42 **PU-07-54** Filed: 3/4/2009 Pages: 3
Turbine Location Revisions to Exhibit 3, Changes –
List & Map

Logan County Wind Farm

Turbine Changes For Maps Submitted on 12/12/08 RE Late Filed Exhibits

Logan County Wind Farm 3/4/09

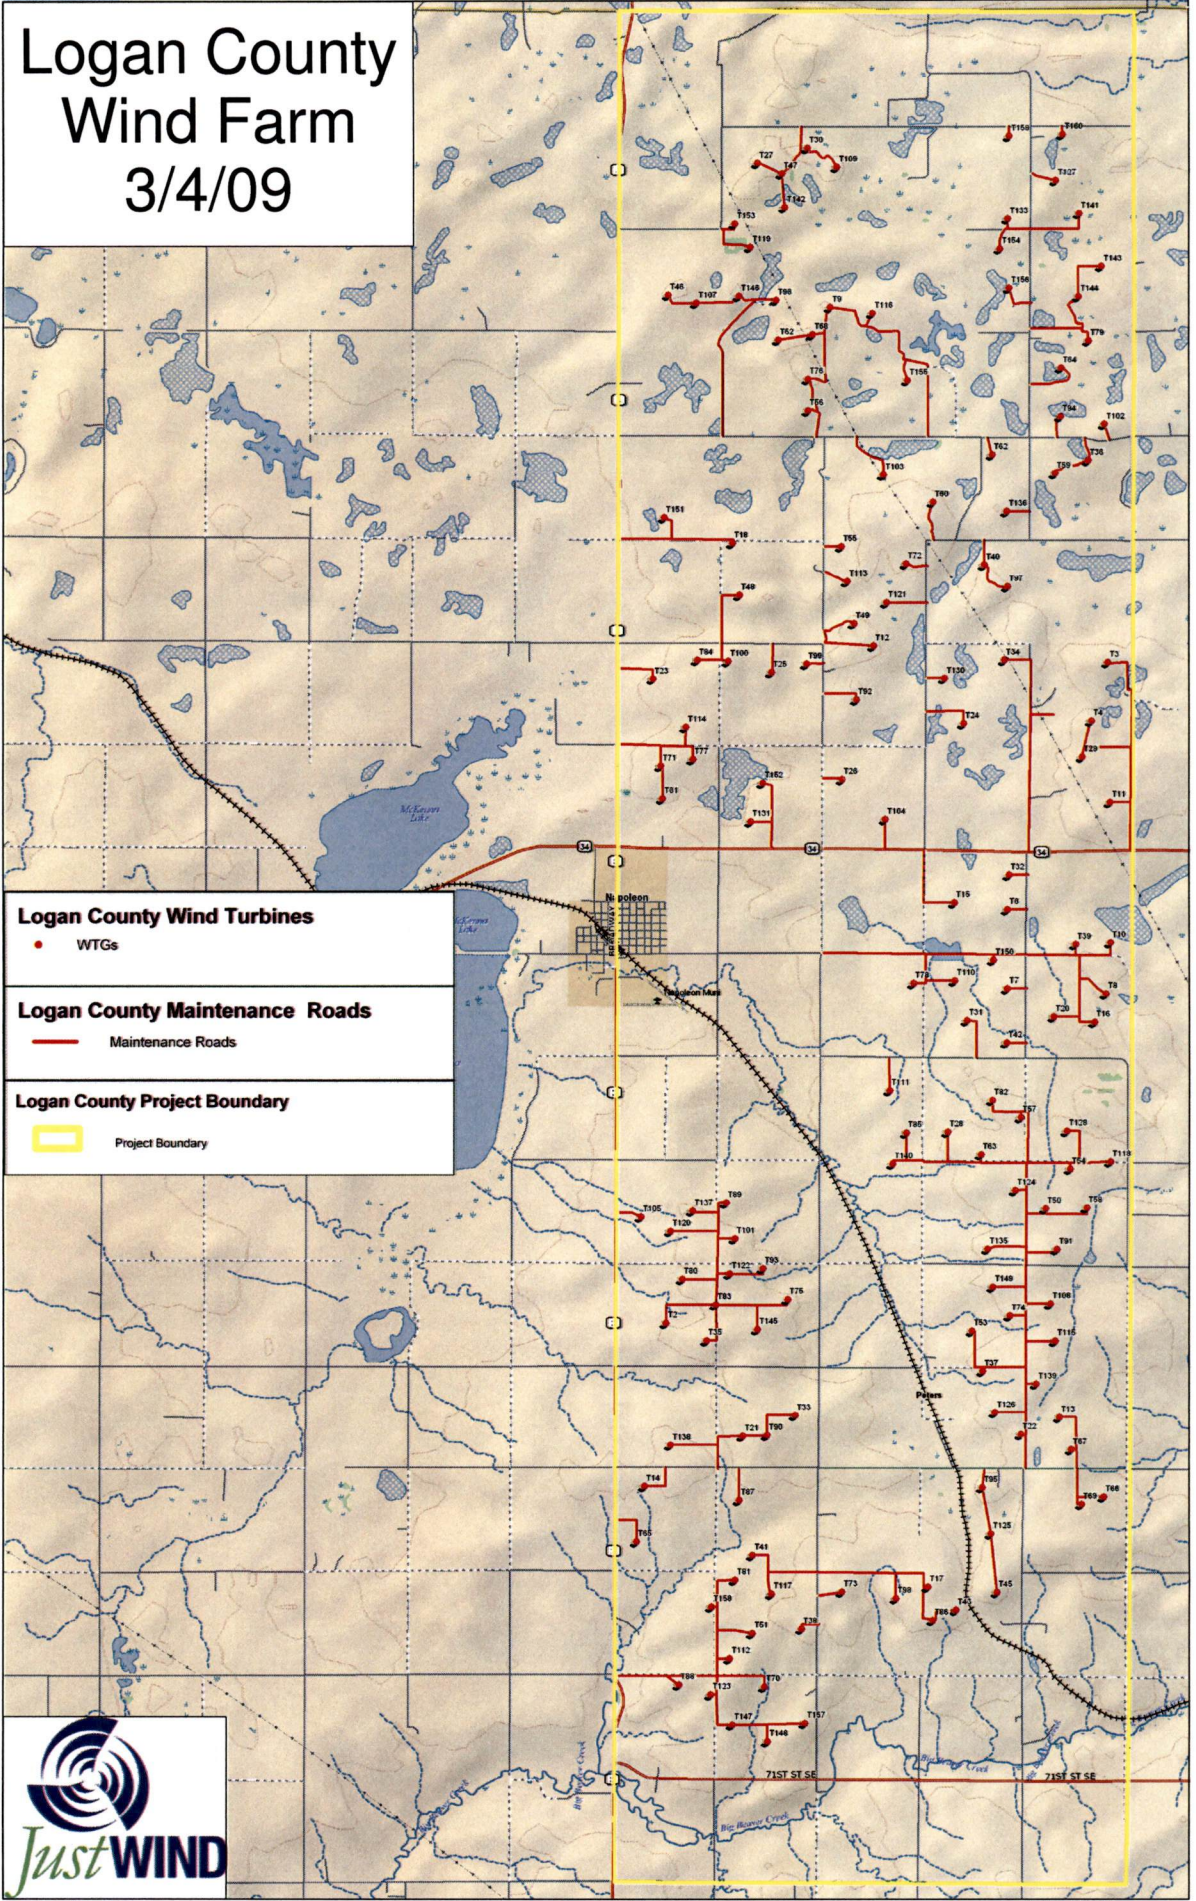
Excluded Turbines:

Eight turbines are being excluded from the project due to a change of turbine model being used from Siemens 2.3 to Mitsubishi 2.4 therefore reducing the impact on the environment.

- T-44 Difficult terrain/Steep grade
- T-1 Landowner financing through FSA
- T-19 Landowner financing through FSA
- T-106 Landowner financing through FSA
- T-132 Too close to residence setback
- T-5 Too close to property line setback
- T-129 Too close to property line setback
- T-134 Access road crosses landowner's feedlot

Relocated Turbines:

- T-133 Moved northeast 3155 feet – Lease on this land was terminated and land became a setback.
- T-55 Moved east 150 feet – Adjacent landowner opted out of project and became a setback.
- T-17 Moved southeast 150 feet – Adjacent landowner became a setback.
- T-41 Moved west 800 feet – Adjacent landowner became a setback.

Possible Relocation:

- T-3 Possible Right of way/Wetland Easement issues
